Environmental Minor Project Refinement Form

Project Name: West of Devers Upgrade Project Request Prepared By: Sylvia Granados

Date Approval Required: 5/17/2018 Variance Request No.: 12

Southern California Edison
West of Devers Upgrade Project
MPR #12-
Bryn Mar Ave - Subtransmission
Work Area Request

FIGURE 1

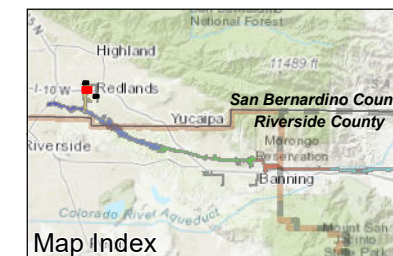
An approximately .29-acre work area is required for material and equipment staging and construction activities associated with subtransmission TSP erection and stringing improvements on the north side of Interstate 10 at the southwest corner of 2255 W. Lugonia Avenue, as shown on Figure 1.

The temporary impacts to developed/disturbed land associated with the new work area are 0.29 acre.
